***“SAPPHIRE” RESIDENTIAL/TOURIST  
DEVELOPMENT OF LOTS 100 & 101 DP  
629555 AND LOT 2 DP 800836***

***740-742 PACIFIC HIGHWAY, SAPPHIRE  
BEACH***

Director-General's Environmental Assessment  
Report  
Section 75I of the  
Environmental Planning and Assessment Act 1979

Figure 4. Proposed Development Layout (Source: Preferred Project Report dated February 2007, plan SK27).

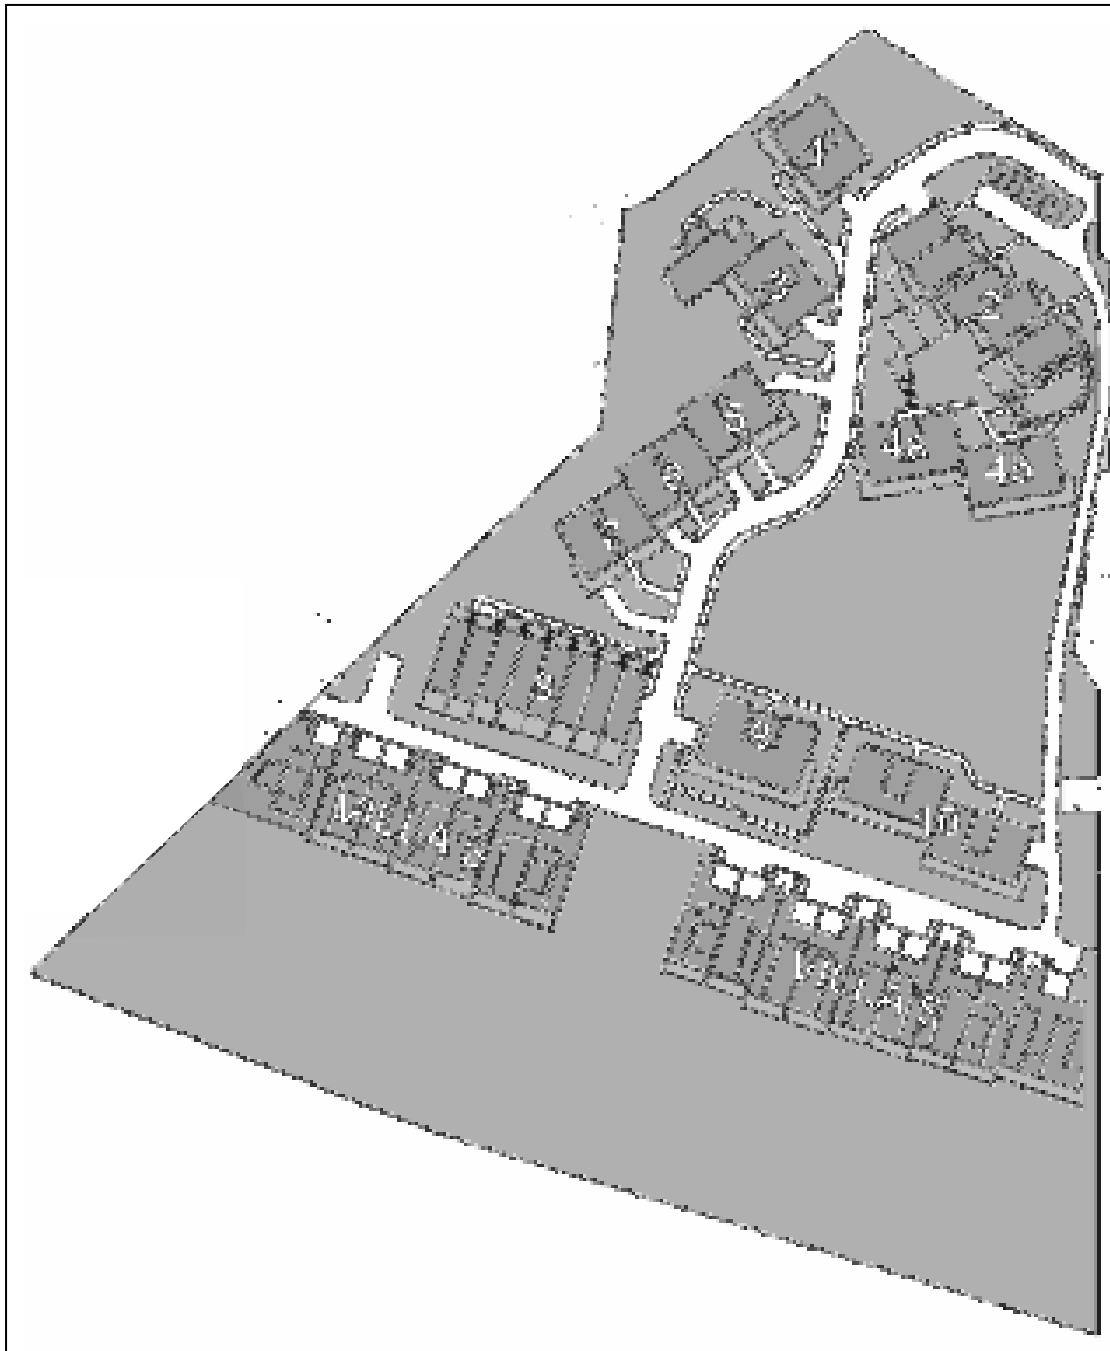
- The buildings closest to the Pacific Highway (Block 2 on Figure 4) reduced in height from four storeys to three storeys.
- Two blocks of buildings at the base of the slope (Blocks 9 and 10 on Figure 4) increased in height from three storeys to four storeys.

- removed one storey from the buildings closest to the Pacific Highway (Block 2);
- added one storey to Blocks 9 and 10; and
- removed one storey from Block 4b.

- Blocks 2 and 4b in the upper part of the site, closest to the Pacific Highway have been reduced to three storeys while Building 4a remains at four storeys (refer to Figure 7);
- Blocks 1, 3, 5, 6 and 7 stepping down the slope on the southern boundary of the site remain at four storeys;
- Blocks 9 and 10 at the base of the slope on the site have been increased to four storeys while Building 8 remains at three storeys; and

The drawing to be approved showing building heights, plan SK26 shows the beachfront dwellings as two storeys. This is not consistent with the indicative elevations as shown on drawing SK08 that shows the dwellings will be part one and part two storeys, thus providing a varied and low scale profile. It is recommended that the concept plan be modified such that the height of the Villas shown on drawing SK26 shall be one and two storey, as shown in elevation on drawing number SK08.
